Subject: Caltrain EMU Base Waiver Extension (Docket Number FRA-2018-0067)

# Caltrain KISS EMU Base Waiver Request Report

## Safety Appliances KISS Caltrain EMU

# Caltrain KISS EMU Base Waiver Request Report

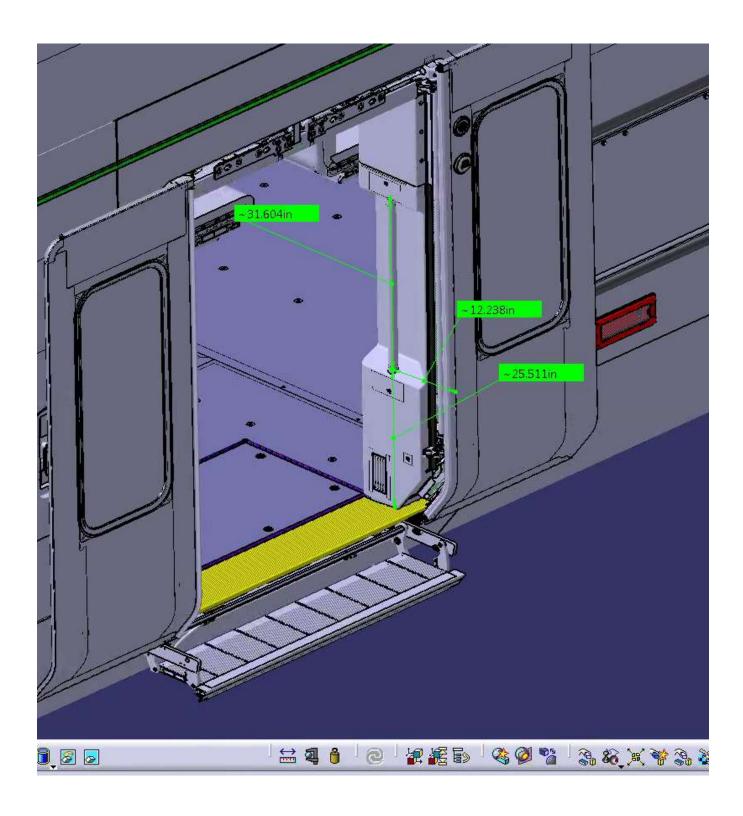
There is not much in the justification portion that outlines the necessity for having such a side-door step design. This KISS EMU is stated to have safety appliances identical in concept to other Stadler equipment currently operating safety in the US under approved FRA waivers, with the exception of these new side-door steps on the lower levels.

• Why is level boarding not available in this corridor (e.g., California Public Utilities Commission General Order 26-D)?

• Additionally, Caltrain utilizes platforms at 8" ATOR and uses mini-high platforms at 22" ATOR to board ADA passengers. So there already seems to be an established method for the non-level boarding that is currently in use in this corridor, so how is this new step system justifiable?

• There are wheelchair accommodations on this EMU, so how will the mini-high platforms at 22" ATOR interface with these steps that extend out towards the platform?

As far as the design of the side-door step, there is not much in terms of explaining the operation.

• It obviously extends and retracts, but what is the mechanism(s) behind this? It looks to be driven by its own motor.

• Is it integrated into the door opening electrical system? Is it independent of the door opening system?

• Is it purely operated via an electrical switch that activates when the Engineer or Conductor pushes a button?

• Is it mechanically integrated into the doorway such that it operates in tandem with the door (extends out as door opens and retracts as door closes)?

• Is there a delay in the step deployment with relation to the door (certainly you don't the door to open before the steps are extended, or the steps to retract prior to the doors closing)?

How will the steps activate in case of manual override during emergency?

• If the steps are mechanically integrated with the door, then how will this impact emergency responders using the doorway for rescue access that may not be expecting a step to extend out?

• What is the vertical load capacity of the steps? It is 51.3" wide with handholds on both sides of the doorway so presumably two individuals can be boarding/alighting at the same time. Assuming two 95th percentile males, can the steps handle the continuous dynamic loading of 450 pounds or more?

As you can see, these are just some of the looming questions that I had regarding the side-door step system. Lastly, FRA has always had the stance that safety appliances be permanently fixed, preferably by means of mechanical fasteners (not welds), so the proposal of a hinged step system that extends and retracts (if approved by the Board) would in fact set a precedence for future safety appliance designs that would be contrary to FRA's stance.

The sliding step below the side doors is installed only as a convenience for passengers and crew boarding from the predominate platform height of 8 inches in the Caltrain infrastructure.

The EMUs are designed to interface with the current Caltrain infrastructure and platforms, which are at 8" above-top-of-rail (ATOR). The boarding and alighting will process will be the same as it is currently. Ambulatory passengers will board using the sliding steps, while wheelchair passengers will board using a 22-inch "mini-high" platform and a manually deployed bridge plate. Sometime in the future, level boarding will be implemented at either the 22" low floor doors or at the 51" high floor doors.

The sliding step is used only for able bodied passengers boarding from the 8" platform level. ADA passengers requiring level boarding, board from the 22" mini-high platform which includes a bridge plate to close the wide gap between the platform and the door threshold of the EMU. It is necessary for the step to be retractable because, when extended, it does not meet the clearance requirements of the system.

The sliding step is not used for interfacing with the 22" mini-high platforms. Interfacing to these platforms is performed exclusively with the manually deployed bridge plate.

The technical functional description of the sliding step is provided in FDR document AL\_2187947 "CDR/PDR/FDR Doors". This document was submitted to John Manutes of the FRA Passenger Rail Division group.

The sliding step extends and retracts with an autonomous motor installed each the unit. The motor is controlled by the door controller and interlocked with the door function.

The sliding step is subordinate to the associated door and door control system. It can only be activated in normal revenue service operation when the associated door is activated. A door open command deploys the associated sliding step prior to opening the door and retracts the sliding step after closing the associated door. The door open/close cycle is not completed without the full deployment and full retraction of the sliding step. The sliding step is also integrated into the "green loop" preventing movement of the train until the sliding step is fully retracted and latched

In normal revenue service operation, the sliding step is activated only when the door is commanded to open. The "open" button resides on the conductor panel and can only be accessed via a crew key.

There is no mechanical interface between the sliding step and door. The sliding step is controlled and monitored over the associated door control unit and is deployed or retracted only when the door is to be opened or closed respectively.

The door opening sequence enforces a complete deployment of the step prior to opening the door. The door closing sequence enforces a complete closing and latching of the door prior to retraction of the sliding step.

For safety reasons, the steps do not activate by manual release handles. The low floor door thresholds are less than 22 inches ATOR, thus not requiring any additional steps for emergency "override" operation (similar threshold arrangement as TexRail FLIRT and DCTA and CMTA GTW's).

Since there is no mechanical integration, the steps remain in place when the doors are opened via emergency release from either inside or outside of the vehicle.

The steps are designed to support 2kN (~450 lbs) over a central load area of 100mm by 200mm, or a load of 5.2kN (~1,170 lbs) distributed over the whole surface of the step without plastic deformation.

The essential purpose of the sliding step is to provide safer access for passengers and crew between the low floor entrance and the 8" platform during revenue service. Although it would be preferred to use the sliding step to assist maintenance and service personnel in the depot or elsewhere during maintenance or non-revenue service, it is not mandatory. The prevention of any unsanctioned use of the sliding step is permanently implemented in the technical setup of the entrance door control system.
